[Docket No. FAA-2011-0054; Directorate Identifier 2010-CE-070-AD; Amendment 39-16582; AD 2011-01-53]

Airworthiness Directives; PIAGGIO AERO INDUSTRIES S.p.A Model PIAGGIO P-180 Airplanes

ACTION: Final rule; request for comments.

Figure 1. Additional drain holes on keel beam webs

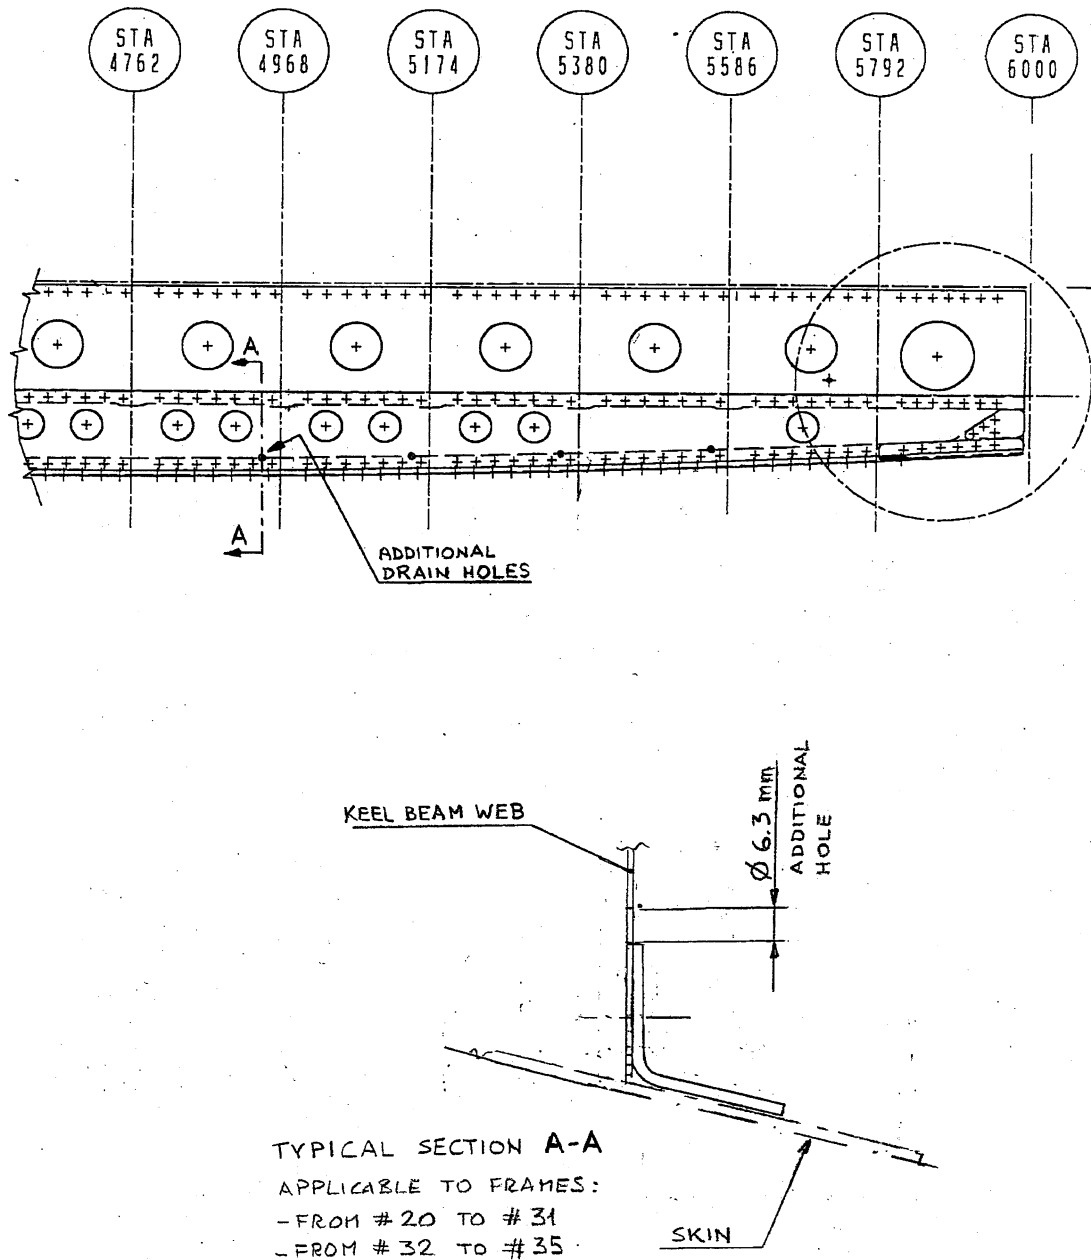
5. Add 6.3 mm draining holes as per attached figure 1 (additional drain holes on keel beam webs) connecting the lateral bays to the center ones or, as alternative, apply Piaggio Aero Industries Service Bulletin 80-0291. Then proceed with step 6.

Figure 2. Fuselage Drain Holes

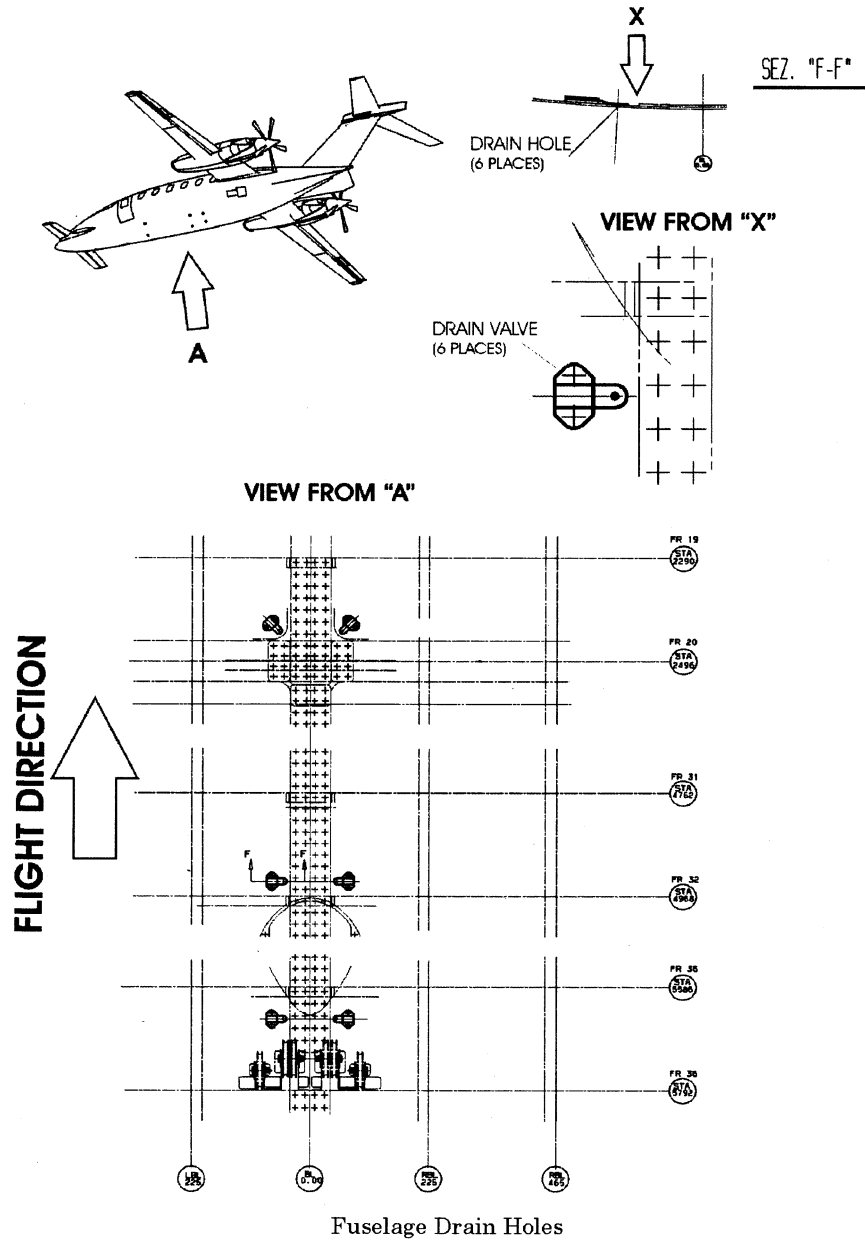
After we issued Emergency AD 2011-01-51, we realized that we inadvertently omitted figure 2 in Appendix 1. This prompted us to supersede Emergency AD 2011-01-51 and issue Emergency AD 2011-01-53.

We are superseding Emergency AD 2011-01-51 with a new AD, which was issued as Emergency AD 2011-01-53 on December 20, 2010. This AD retains the actions from Emergency AD 2011-01-51, adds figure 2 to Appendix 1, and corrects other minor typographical errors.

- a. Place an adequate amount of water in each bay between FR 19 and FR 36 (See figure 2) to verify that the water is conveyed in the central bays and that it is drained. Use at least ½ gallon (approximately 2 liters).
NOTE: TAKE CARE NOT TO COME IN CONTACT WITH ELECTRICAL CONNECTORS WHILE POURING WATER.
- b. A steady stream of water should be observed coming from the external drain holes. If not, the flapper valve does not drain properly. Cut off the rubber flap and replace the flapper valve at next A check. Take note of any cut rubber flap and its position.
13. Dry the fuselage belly.
